**Re: Engineering Geology Assessment-Revised
Lot 15, Ski Lake Estates No. 3
6640 East 1100 South
Huntsville, Utah
Job No. 145150**

**Re: Engineering Geology Assessment-Addendum II
Lot 15, Ski Lake Estates No. 3
6640 East 1100 South
Huntsville, Utah
Job No. 145150**

The purpose of this letter is to respond to the second geology review comments⁵ provided by Simon Associates, LLC, third-party consultant, hired by Weber County to review the referenced geology assessment letter.

PHOTO EXHIBIT 1

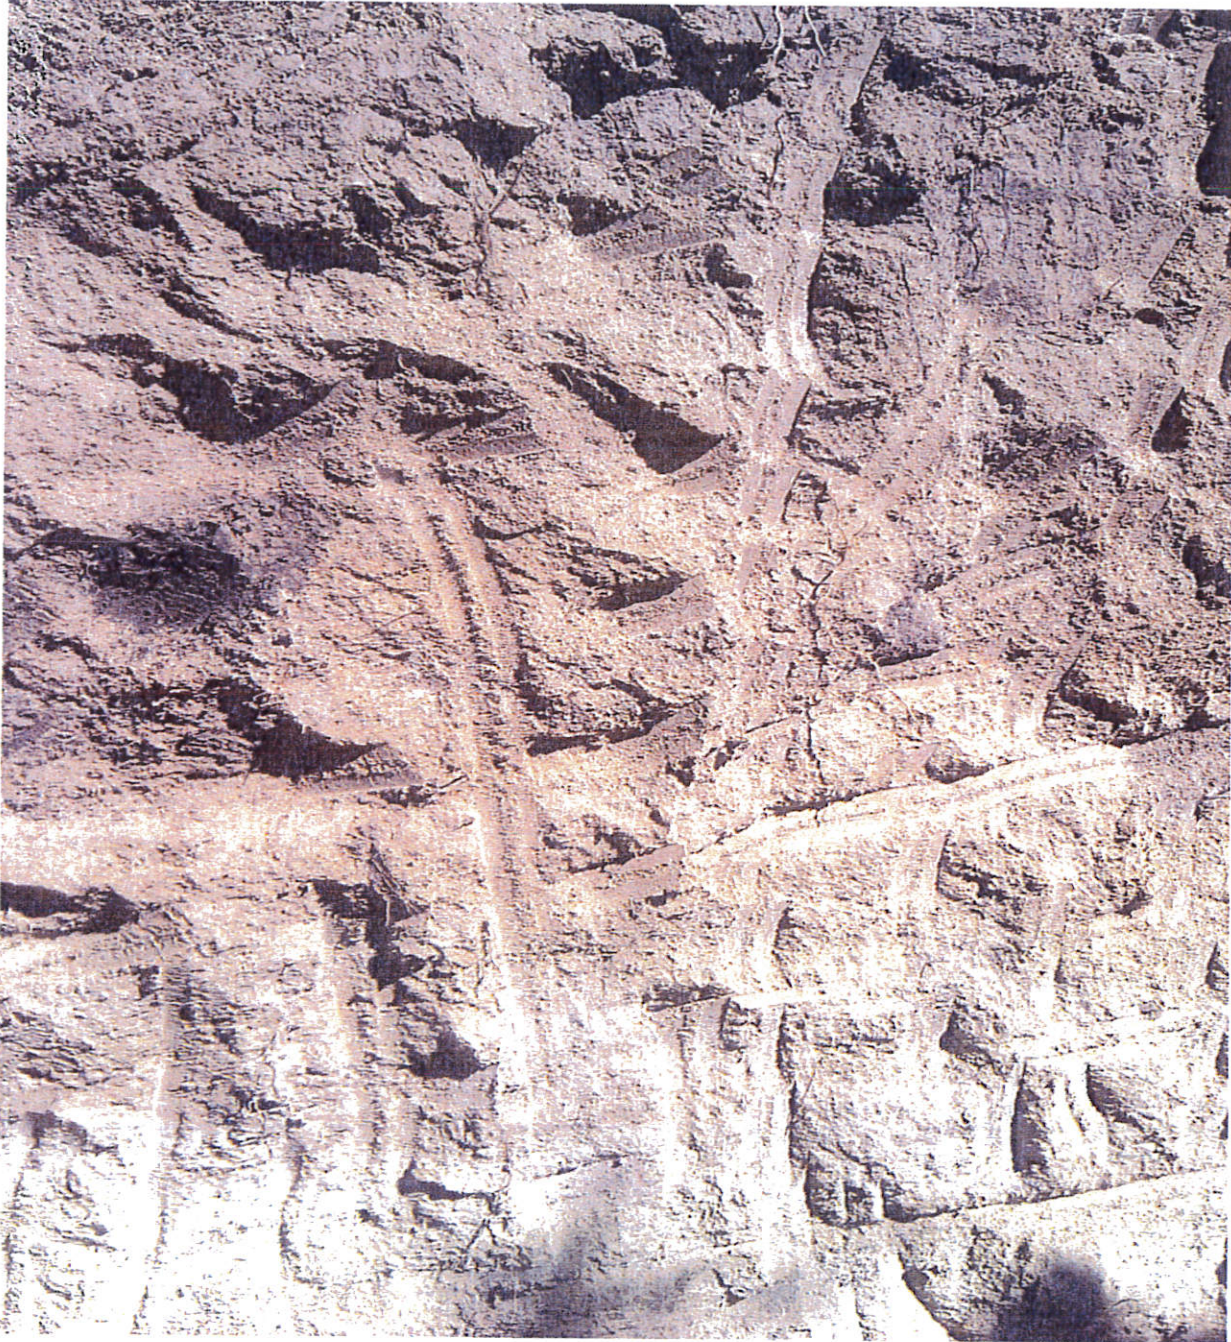
Review Comment 4 states: *"Item 3 of the August 6, 2015, SA review letter recommended Weber County request annotated photographs of TP-5 and the extension of TP-3 excavated on 6-22-2015. The photographs submitted with the August 14, 2015, EEl addendum were not annotated. SA recommends Weber County request annotated photographs of TP-5 and extension of TP-3 excavated on 6-22-15."*

Test pit TP-3 and its extension was photographed as shown in Exhibit 1 through 3, Appendix A. Photographs of TP-5 were not taken, and this test pit was backfilled.
